SYMBOL	DESCRIPTION	DATE	APPR.
REVISIONS			
OFFICE OF CARL R. BLANCHARD JR. ARCHITECTS	DEPT. OF THE NAVY BUREAU OF YARDS & DOCKS		
NEW HAVEN, CONNECTICUT	DISTRICT PUBLIC WORKS OFFICE		
	THIRD NAVAL DISTRICT		
	U.S. NAVAL SUBMARINE BASE - NEW LONDON - GROTON, CONNECTICUT		
CHapel & Religious Education Building			
PLOT PLAN, LOCATION MAP & TEST BORING DATA			
DESIGNED BY [Signature]	DATE [Date]	CODE IDENT NO	SIZE
DRAWN BY [Signature]	DATE [Date]	1082655	33" x 42"
APPROVED [Signature]	DATE [Date]	NBY 63823	
OFFICER IN CHARGE	DATE [Date]	SCALE AS NOTED	SPEC 63823/65
APPR. FOR BLDG. OFFICE	DATE [Date]		
APPR. FOR CHIEF OF BUREAU	DATE [Date]

SYMBOL	DESCRIPTION	DATE	APPR
△	DRIVE, PARKING AREA & GRADING MODIFIED; WALKWAY FEEL LANE ELIMINATED.	6/9/68	
△	REV LAYOUT OF DRIVE & DRAINAGE	4/5/68	
REVISIONS			
OFFICE OF CARL R. BLANCHARD JR. ARCHITECTS NEW HAVEN, CONNECTICUT		DEPT. OF THE NAVY THIRD NAVAL DISTRICT NEW YORK, N.Y.	
DES. WD. DR. RG. CHK. WD. SUPV. CC. CH. ENGR. CC.		BUREAU OF YARDS & DOCKS DISTRICT PUBLIC WORKS OFFICE NEW YORK, N.Y.	
U.S. NAVAL SUBMARINE BASE - NEW LONDON - GROTON, CONNECTICUT			
CHAPEL & RELIGIOUS EDUCATION BUILDING			
PLOT PLAN			
APPROVED	DATE	CODE IDENT NO.	SIZE

**DETAIL #1**  
LAYOUT OF DRIVE AND DRAINAGE

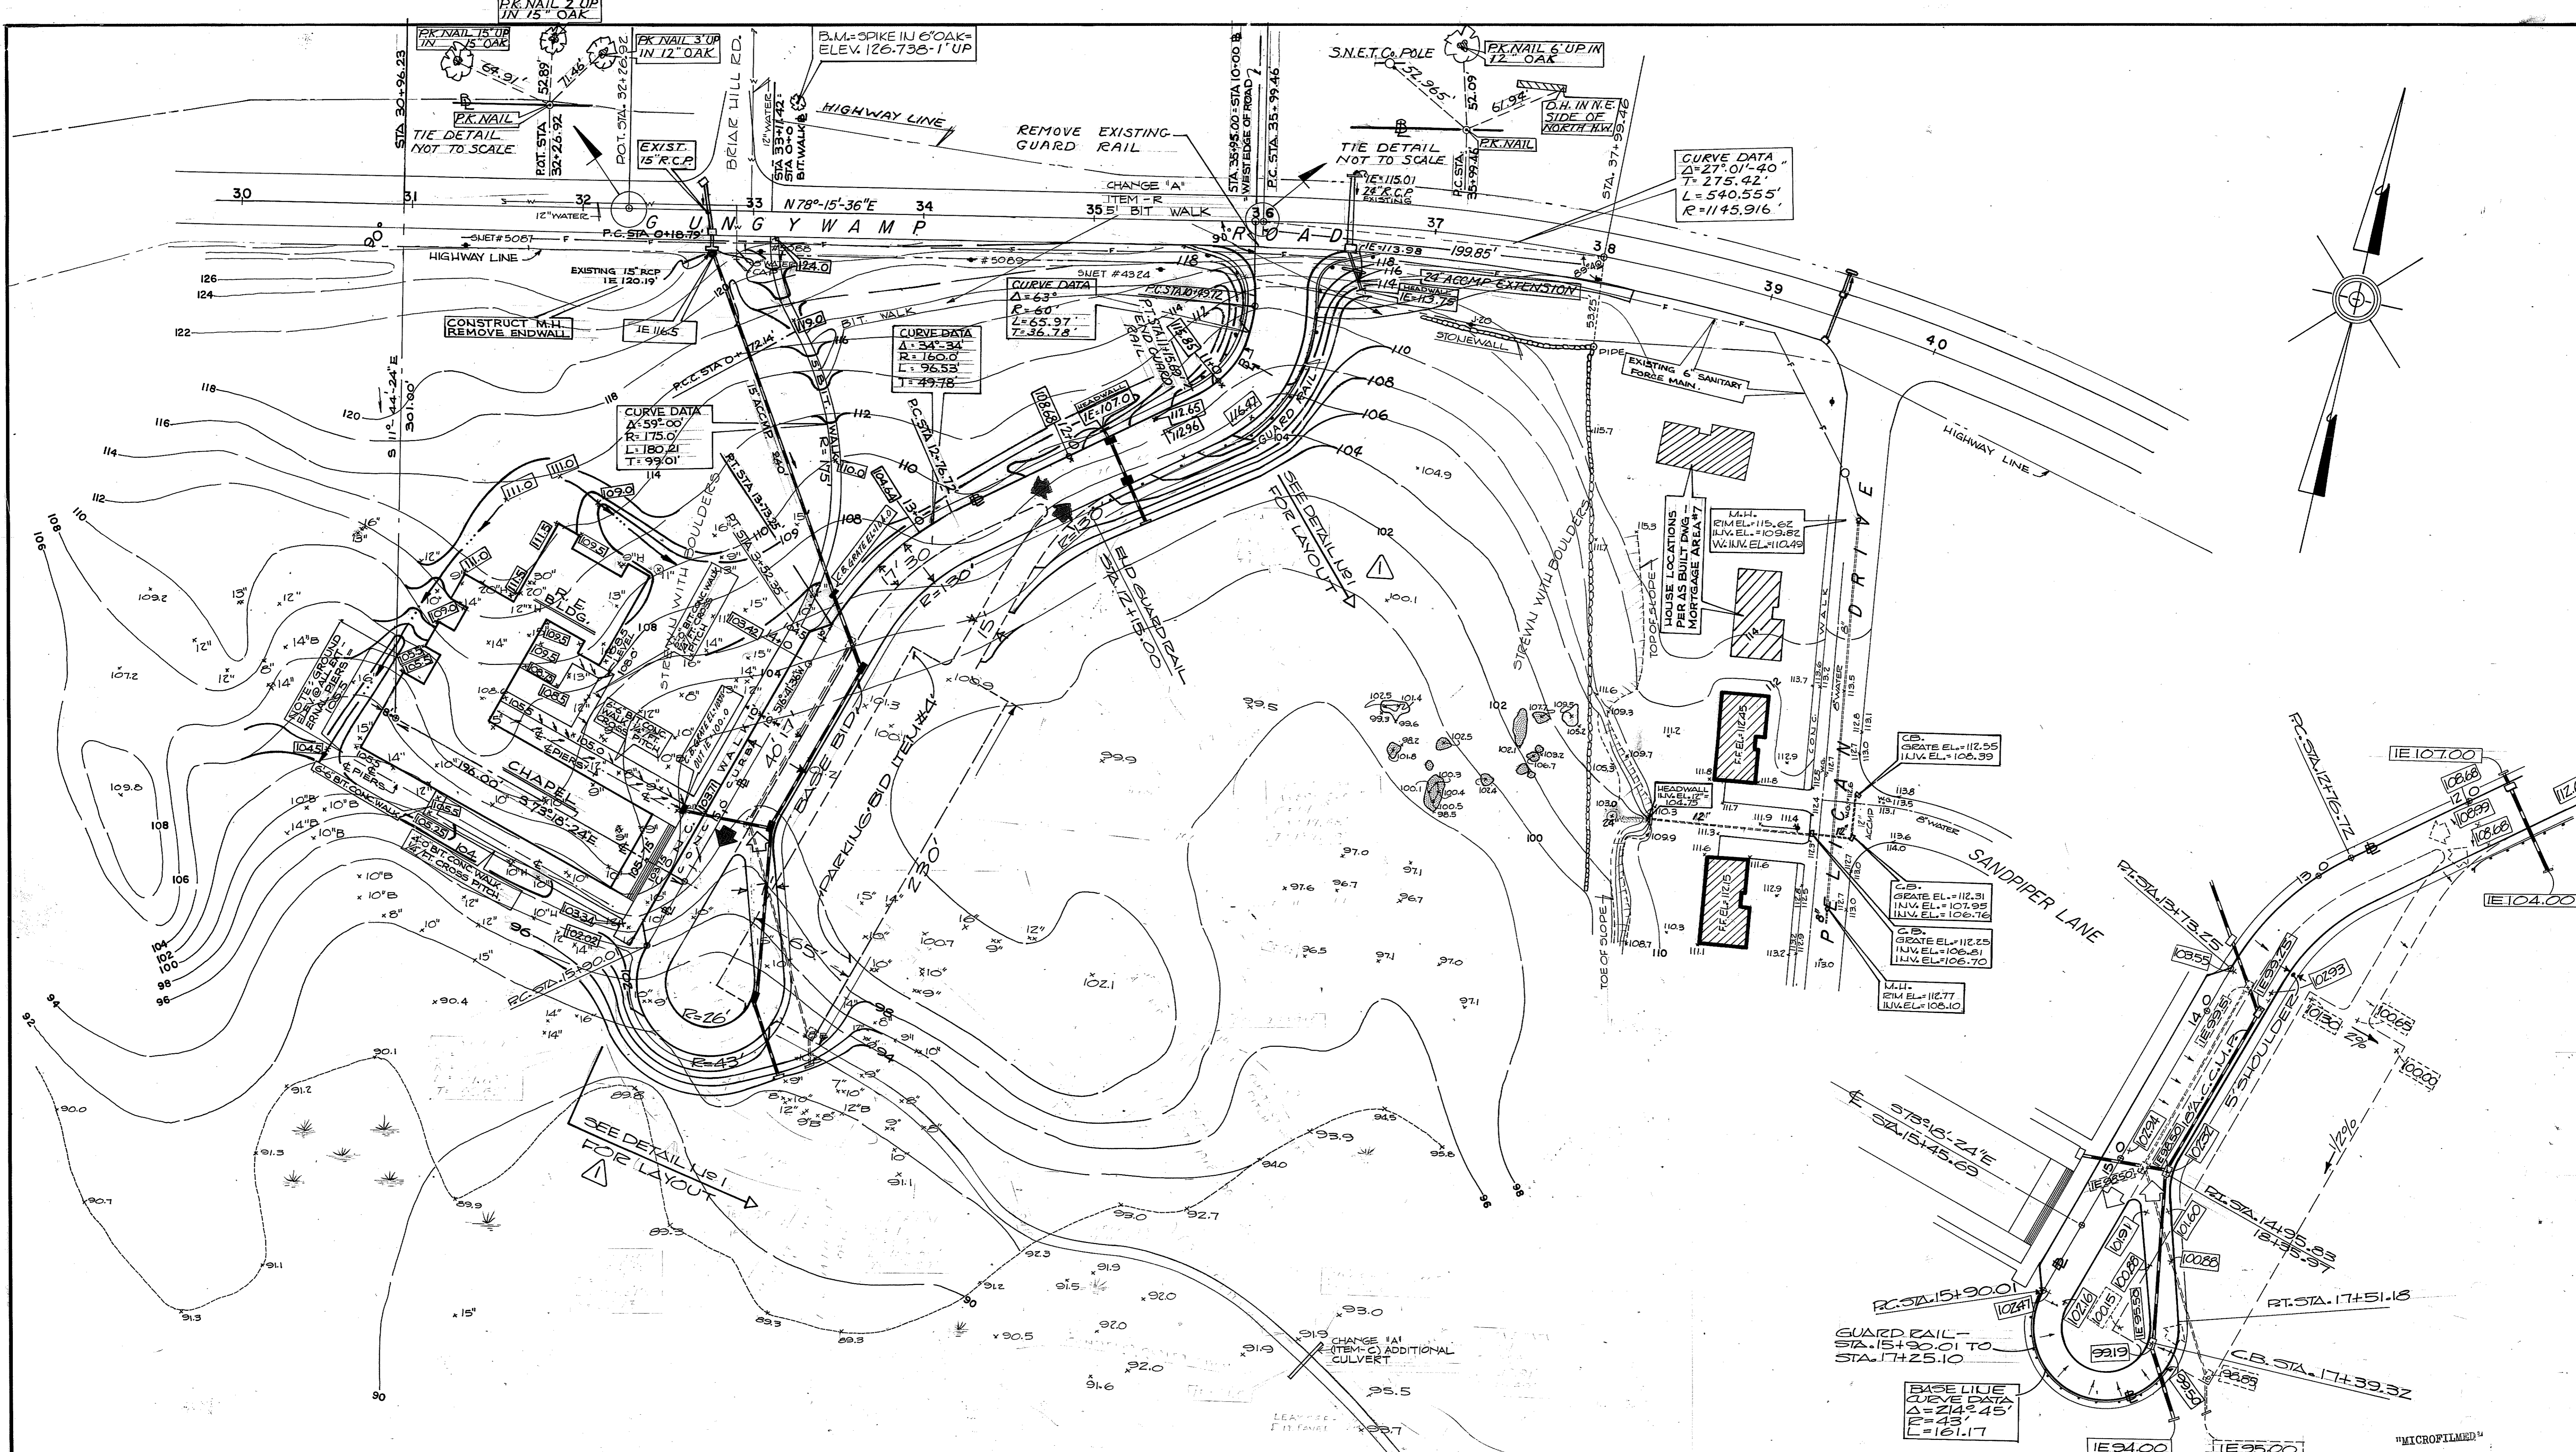
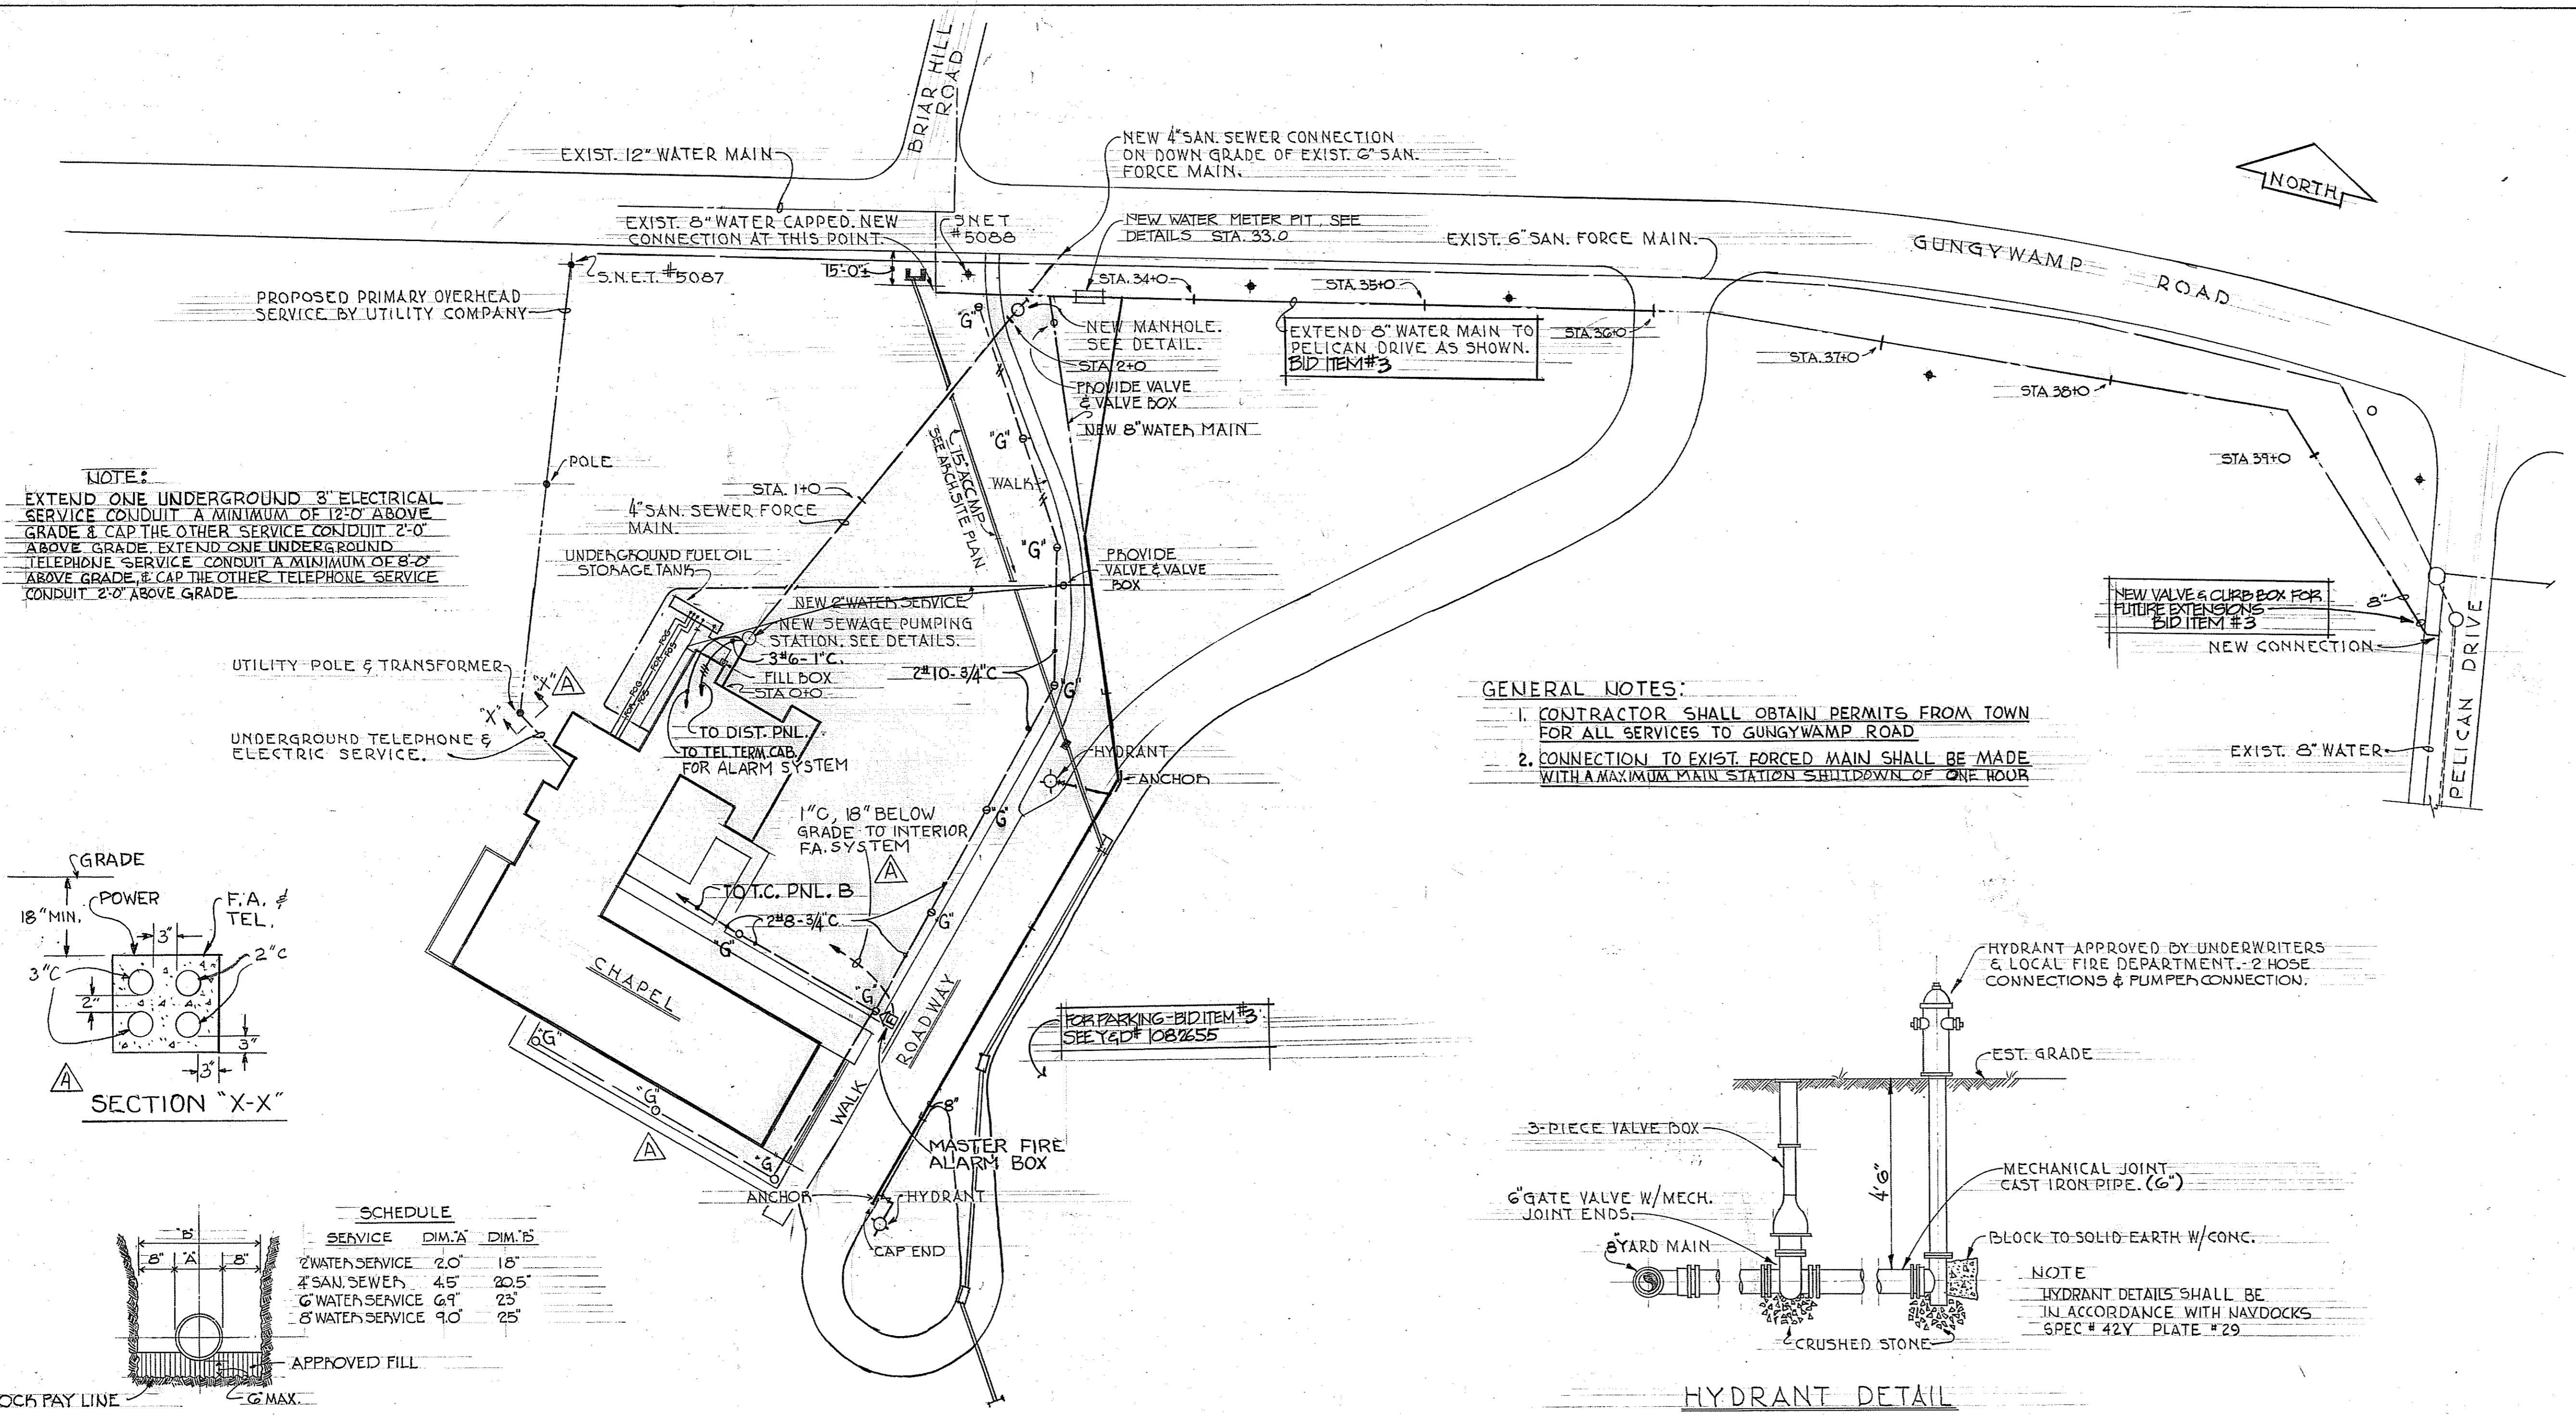
CHANGE 'A' (ITEM 1-B) PROVIDES FOR: ADDITIONAL 100 LBS. CU. YDS. OF MASS ROCK & TRENCH ROCK REMOVED.  
CHANGE 'A' (ITEM 1-C) PROVIDE FOR: INCREASE DOSEAGE OF SOIL POISONING.  
CHANGE 'A' (ITEM 1-D) PROVIDE FOR: CHANGE MORTAR COLOR AS REQUESTED BY 'X' & 'E'.  
CHANGE 'A' (ITEM 1-E) PROVIDES FOR: CHANGE DESIGN OF DOOR DETAIL.  
1. METER PIT BEING RELOCATED  
2. WATER LINE - RELOCATE

1. ADD ONE BIT WALK - 5'-0" WIDE NORTH OF CHAPEL.
2. ADD 5'-0" WIDE BIT WALK SOUTH OF CHAPEL.
